City of Portland, Maine - Building or Use Permit Application

| Permit No: 03-0094 | Issue Date: FEB 14 2003 | CBL: 044 B028001 |

| Location of Construction: 15 Stetson Ct | Owner Name: Cedrone David Nunzio & | Owner Address: 15 Stetson Ct | Phone: 207-772-7522 |

Proposed Project Description:
Remove interior loadbearing walls and install 3 windows.

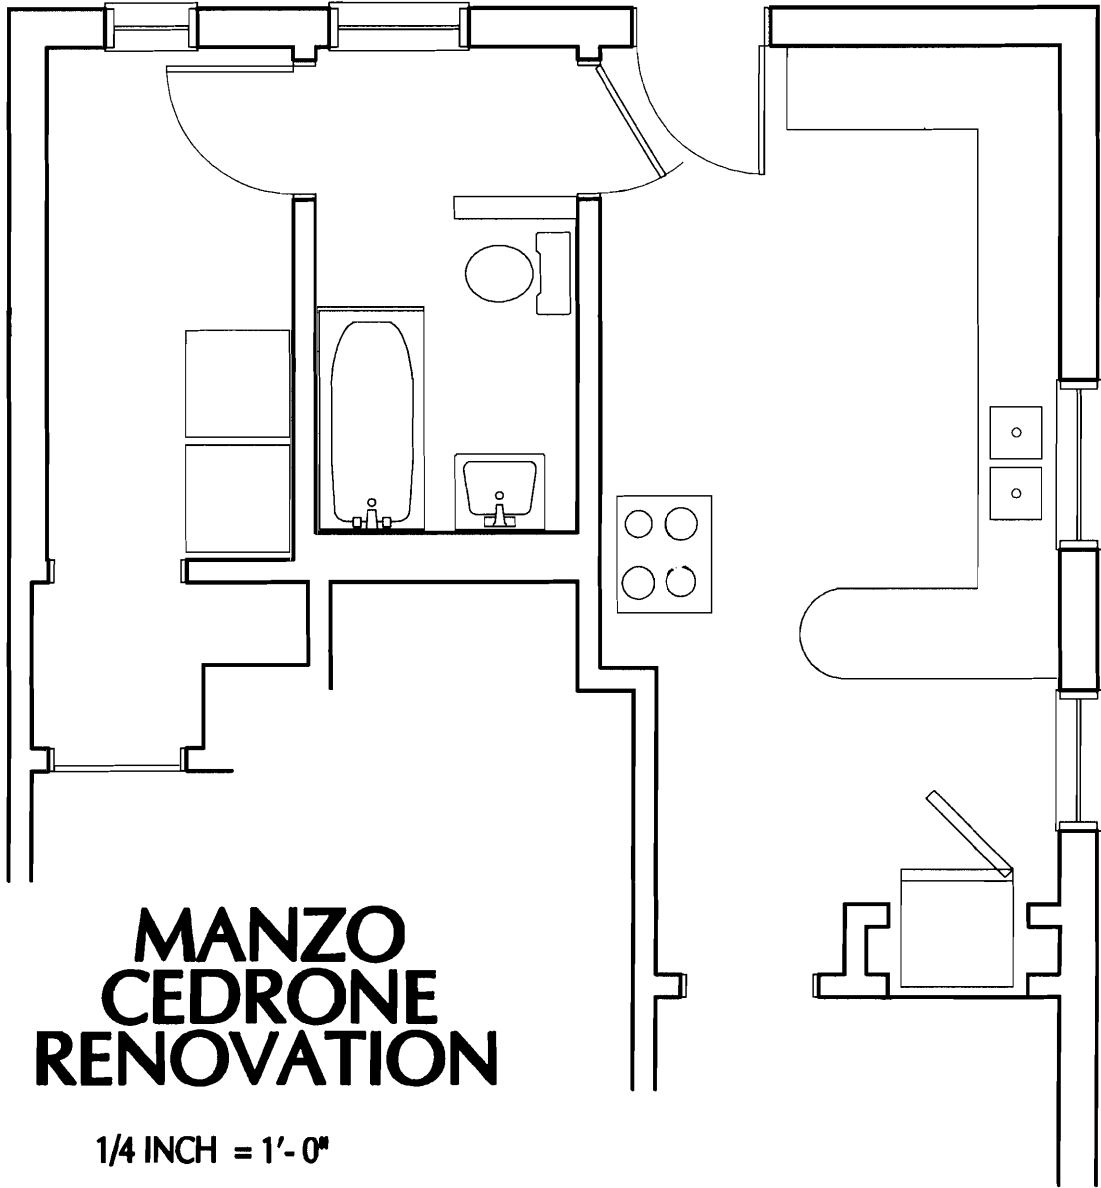
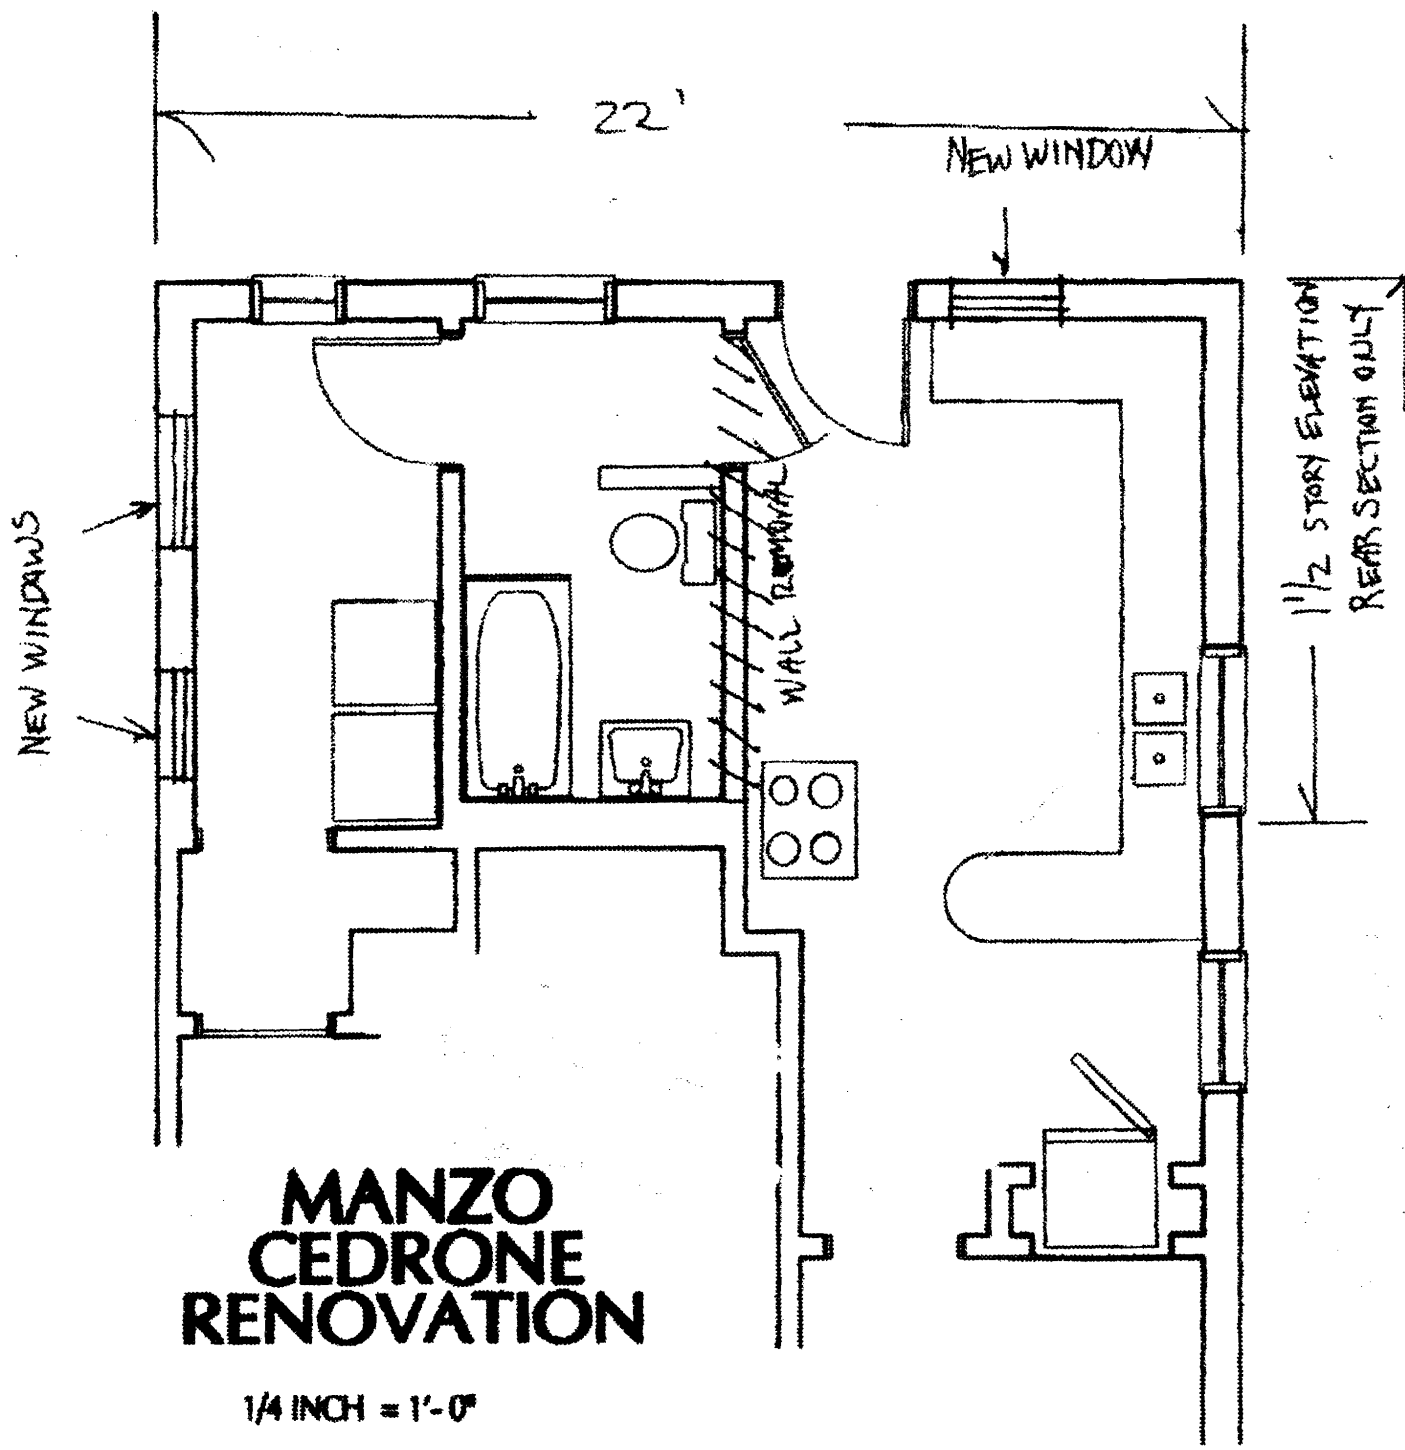
First floor unit kitchen to be expanded. Center load bearing partition is carrying second floor only with no partitions, therefore no roof load. Roof load transmits in a conventional manner in standard "cape" style to outer load bearing first floor walls. **Propose to open the center partition wall 11 feet.** Outside north wall, which does not have roof load bearing, to have jacks added in wall to support one end of LVL header. They will transmit down to pressure treated sill/girder system in crawl space, which was new construction within the past eight years on top of new piers (sonotubes) at recommended spans. Opposite end of LVL to bear on jacks added in wall, which will transmit down to brick foundation of main house. Solid blocking as required to fill space between subfloor and sill, grain to be placed in vertical manner. LVL to be placed under 2nd floor (not flush) in order that the floor will continue to tie the roof system. Any structural hangers, as needed, to be specified from current Simpson StrongTie, USP, or comparable manufacturers' specification book. All construction to be performed in accordance to new International Code or latest BOCA. LVL's to be from Georgia Pacific, TrusJoist, or comparable and appropriate engineering guides to be used.

Based upon new floor joist span of 22', standard loading of 40#LL with 12#DL, to be used. LVL to have span of no greater than 11', resulting in 1144#PLF. Correct 2-ply or 3-ply header to be installed, such as a 3.5" x 11.875".

Exterior windows to used conventional headers, such as 2-2x8, sized for opening. Bonneville 3129WAG11, natural, flat csg, 6-lite SDL, or the equivalent.

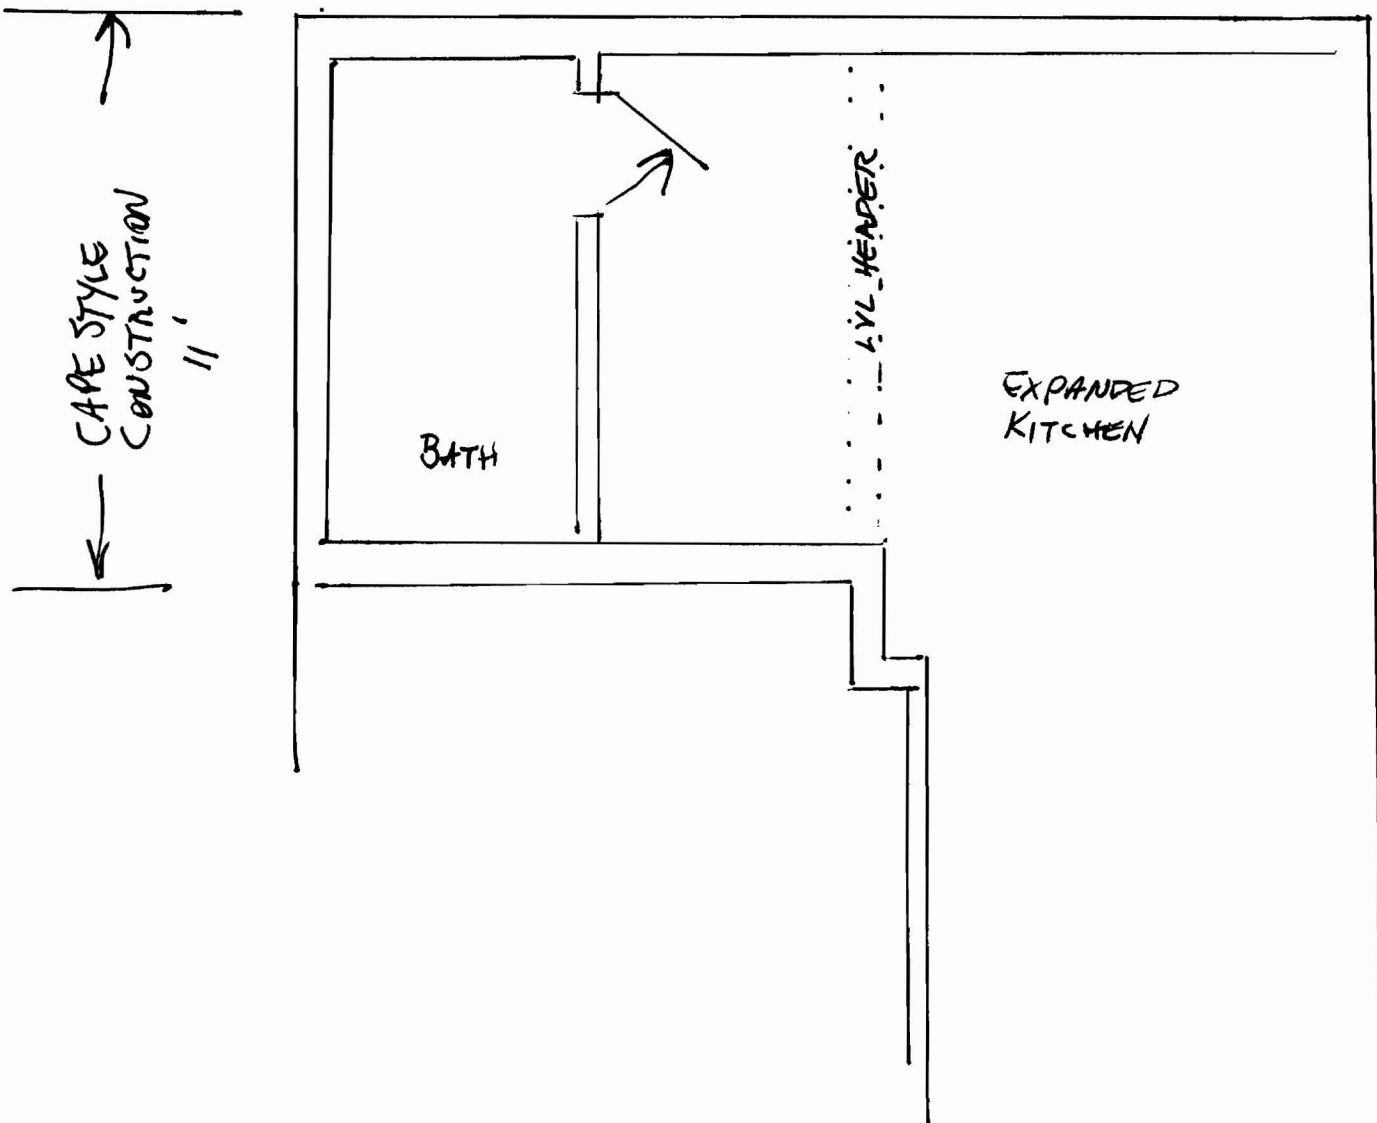
← 22' →
RIDGE LINE

2ND FLOOR LOAD ONLY - NO ROOF

242# @ 40LL + 12PL = 52 TL = 12,584

2662# p/f
1144# r/f
